Joint Waste Local Plan

Schedules of Modifications made to the Waste Local Plan following Examination in Public

Schedule of Main Modifications for the Merseyside and Halton Waste Local Plan

Appendix B: Consequential Modifications to Figure 4.2 (due to changes to policy WM2 and WM5)

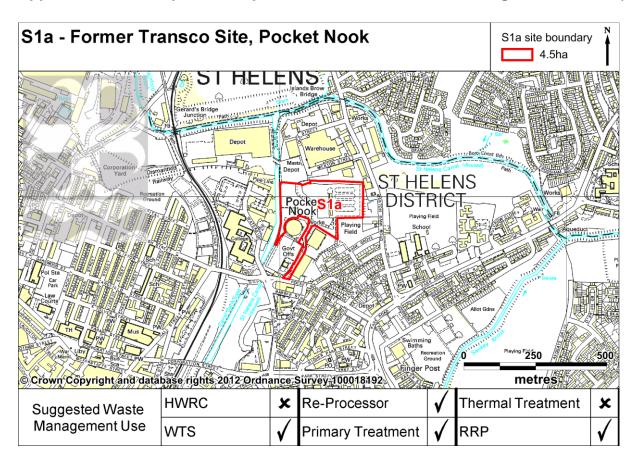
AM-047	Section 4 Figure 4.2	Update figure to remove site H3 (Runcorn WwTw) and replace sub-regional site in St Helens. Update all Environment Agency data. Make reference to supporting document PS-044	N/A	For clarification and to include most up-to-date information.
